SUBJECT: RELAXATION OF THE REQUIREMENTS OF ORDER EA-03-009, DATED FEBRUARY 11, 2003, REGARDING EXAMINATION COVERAGE FOR REACTOR PRESSURE VESSEL HEAD PENETRATION NOZZLES FOR BEAVER VALLEY POWER STATION, UNIT NO. 2 (TAC NO. MC0237)

SAFETY EVALUATION BY THE OFFICE OF NUCLEAR REACTOR REGULATION

ORDER EA-03-009 RELAXATION REQUEST

BEAVER VALLEY POWER STATION, UNIT NO. 2

Figure 1: BVPS Unit 2 CRDM Penetration Nozzle Configuration  
Outermost Penetrations

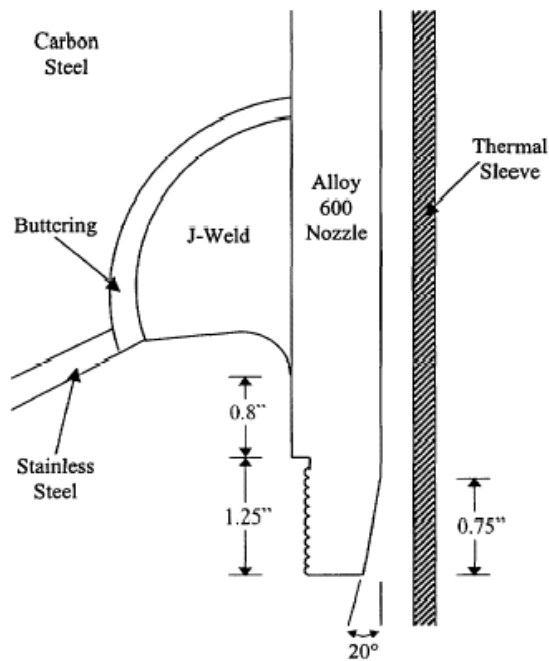
In its supplemental letter dated December 19, 2003, the licensee provided the field results showing the actual inspection distances achieved below the J-groove welds during its 10<sup>th</sup> refueling outage required by Section IV, paragraph C.2(b) of the Order. The NRC staff notes that these inspections were not required to be performed since a BMV had been accomplished that same outage and BVPS-2 is a moderate susceptibility plant. A drawing of a BVPS-2 CRDM penetration is shown below with the field measurements taken during the BVPS-2 10<sup>th</sup> refueling outage tabulated below. The drawing shows that the most limiting distance is on the downhill side of the J-groove weld where the nozzle distance is the shortest.

From the table above the NRC staff notes that the licensee inspected further down the nozzle than the expected tip of the postulated flaw distance from the J-groove weld for the flaw growth analysis. This would make the total distances below the J-groove welds that were examined as crack free: 1.08 in., 0.84 in., 0.80 in., 0.77 in., and 0.4 in., respectively, for the penetrations listed above.

Figure 6-15 Through-Wall Axial Flaws Located in the 38.7 Degrees Row of Penetrations, Uphill Side - Crack Growth

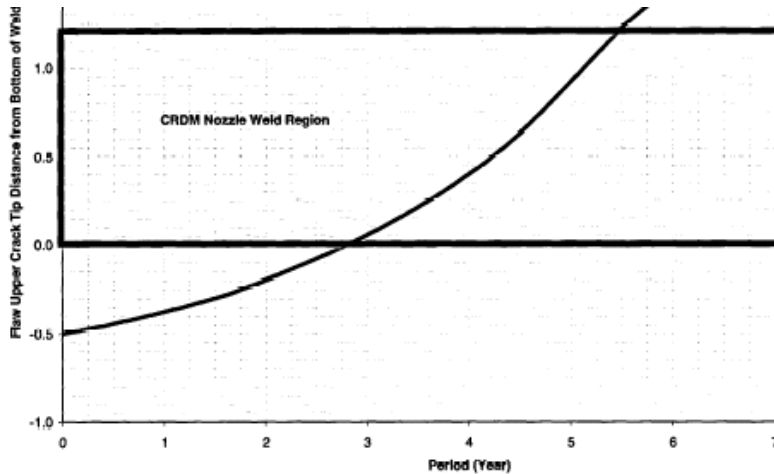
may be located sufficiently below the attachment weld that additional time may be required for the flaw to grow to the attachment weld. To provide a means to evaluate the duration of this additional time, a series of flaw tolerance charts for through-wall flaws were prepared by the licensee. Below is an example of one such flaw tolerance chart:

The flaw tolerance charts and the plant-specific hoop stress distribution charts provided by the licensee in WCAP-16144-P, Rev. 0, indicate that the licensee will be able to operate 6.1 EFY without an existing crack in the uninspected region propagating to the bottom of the J-groove welds, provided the minimum inspection distances below the weld are consistently achieved during the course of subsequent inspections.

The NRC staff notes that the stated EFY of permitted operation in the table above is predicated on achievement of the minimum inspection distances below the weld as determined by the licensee's plant-specific analysis. The licensee has justified operation for the operating period specified under Section IV, paragraph C.(2) for a moderate susceptibility plant. The NRC staff concludes that the licensee may claim credit for satisfying the requirement under Section IV, paragraph C.(2)(b) per the Order, because the alternative performed is supported by the crack-growth evaluation. Furthermore, the NRC staff concludes that the licensee must perform a BMV examination per Section IV, paragraph C.(2)(a) during the BVPS-2 11<sup>th</sup> refueling outage in order to comply with the testing frequency requirements of the Order. The licensee stated that for the BVPS-2 12<sup>th</sup> refueling outage, the projected susceptibility is high. At that time, the NRC staff concludes that the testing frequency of Section IV, paragraph C.(1) shall apply and that the examinations under Section IV, paragraphs C.(2)(a) and (b) will be performed every refueling outage.

If the NRC staff finds that the crack-growth formula in industry report MRP-55 is unacceptable, the licensee shall revise its analysis that justifies relaxation of the Order within 30 days after the NRC informs the licensee of an NRC-approved crack-growth formula. If the licensee's revised analysis shows that the crack-growth acceptance criteria are exceeded prior to the end of the current operating cycle, this relaxation is rescinded and the licensee shall, within 72 hours, submit to the NRC written justification for continued operation. If the revised analysis shows that the crack-growth acceptance criteria are exceeded during the subsequent operating cycle, the licensee shall, within 30 days, submit the revised analysis for NRC review. If the revised analysis shows that the crack-growth acceptance criteria are not exceeded during either the current operating cycle or the subsequent operating cycle, the licensee shall, within 30 days, submit a letter to the NRC confirming that its analysis has been revised. Any future crack-growth analyses performed for this and future cycles for RPV head penetrations must be based on an acceptable crack-growth rate formula.
